HISTORIC AND DESIGN REVIEW COMMISSION June 19, 2019

HDRC CASE NO: 2019-284

ADDRESS: 1119 N ST MARYS

TYPE OF WORK: Installation of a new pole for network node equipment

View from Brooklyn St looking north at site

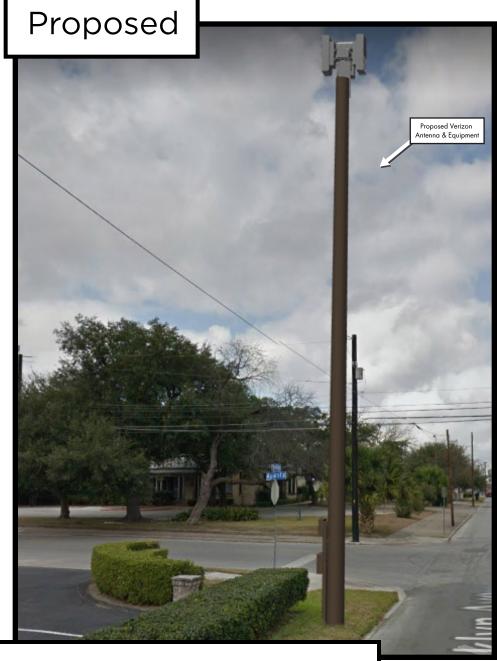
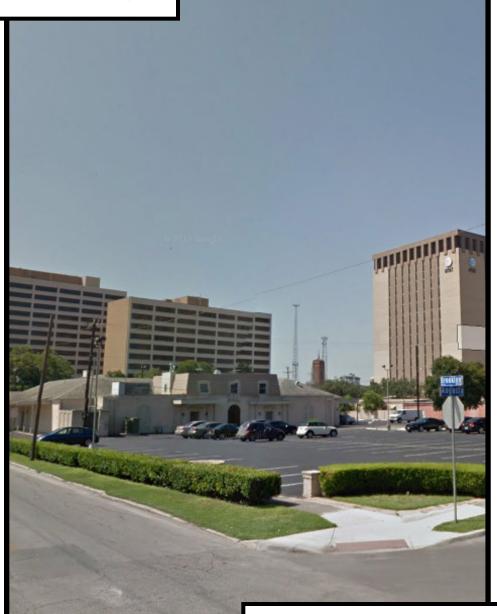
- i. DESIGN The applicant has proposed to install a wood pole with a meter socket (box), service disconnect (box) and linear conduit up to six feet (6') and three (3) au/rap units (grey cabinets) that are 11.4 inch wide, 14.6 inch tall, and extend no more than one feet (1') from the wood pole. The applicant referenced existing wood utility poles in selecting the pole type in this location. Per the Design Manual 3.B.: *The Historic Preservation Officer may require concealment of the support pole in the form of aesthetically appropriate street lamps, site elements, district signage, or other stealth methods. The color of any new support pole or concealment solution shall be determined by the Historic Preservation Officer based on site specific conditions.* Staff finds that no effort has been made to conceal or relate the proposed new pole to the existing context or site elements at N Mesquite except the use of a wood pole and matching equipment color.

- i. COLLOCATION Documented efforts to explore a nearby collocation have not been submitted.
- ii. SEPARATION The proposed pole is not separated from existing poles by more than 250 feet.
- iii. DIAMETER The proposed pole is not less than 8 inches at its widest portion.
- iv. DESIGN Matching wood material to existing poles does not constitute a stealth aesthetic.

ELEVATIONS

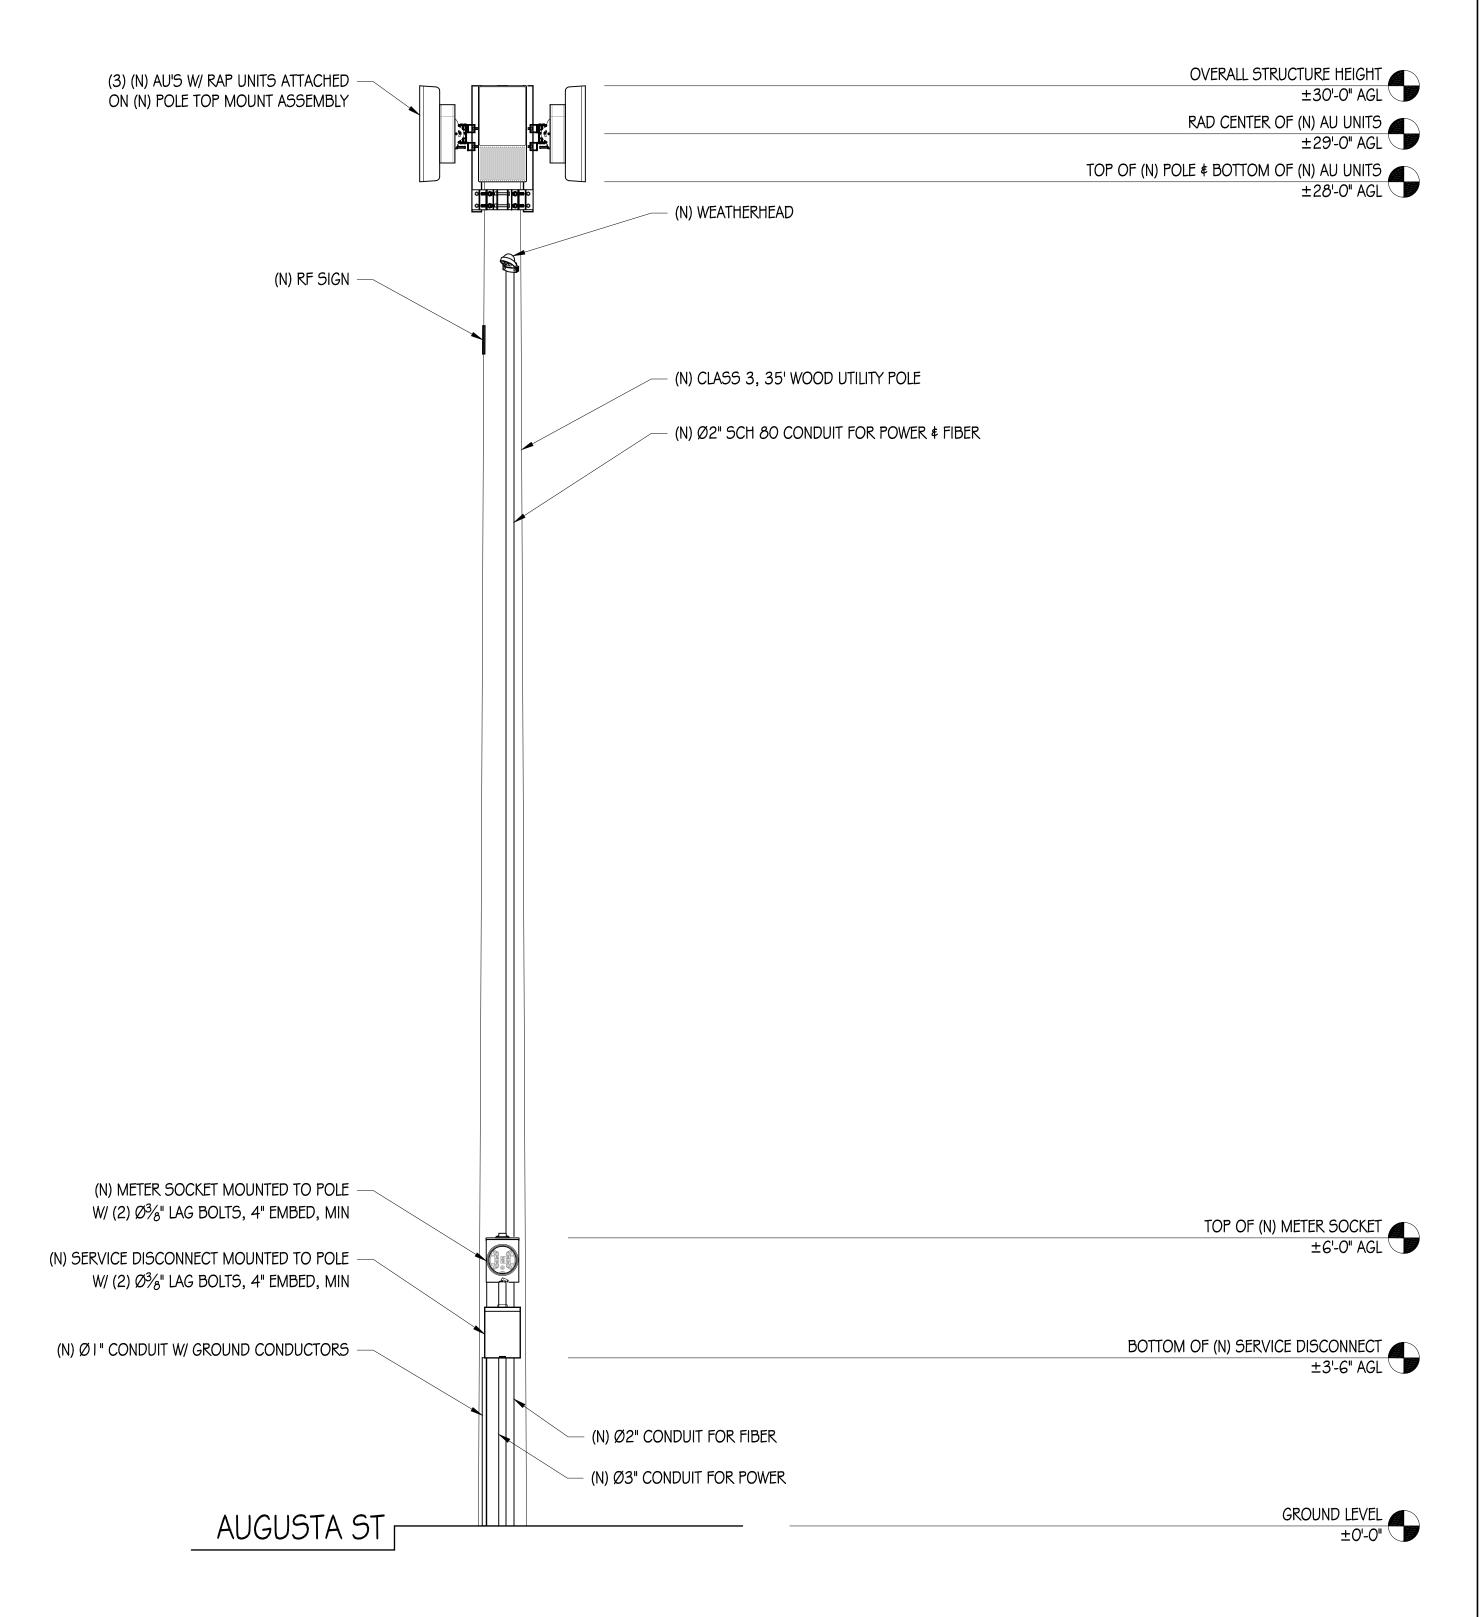
- g. HEIGHT The applicant has proposed to install a wood pole including node equipment featuring a total of thirty feet (30') from grade. Per the Design Manual 3.B.iv., the height of new node support poles should not exceed the established predominant height of other poles and historic site elements located within 500 feet of the proposed installation. Staff finds that the proposed height is subordinate to existing poles within proximity.

- h. DIAMETER The applicant has proposed to install a pole that is 32 inch (32") in diameter excluding the meter boxes at the pedestrian level and the antenna cabinets at the top. Per the Design Manual 3.B.v., new poles should not exceed 8 inches (8") in diameter at the widest portion of the pole. Staff finds that the proposed pole diameter is four times wider allowed by the design manual.
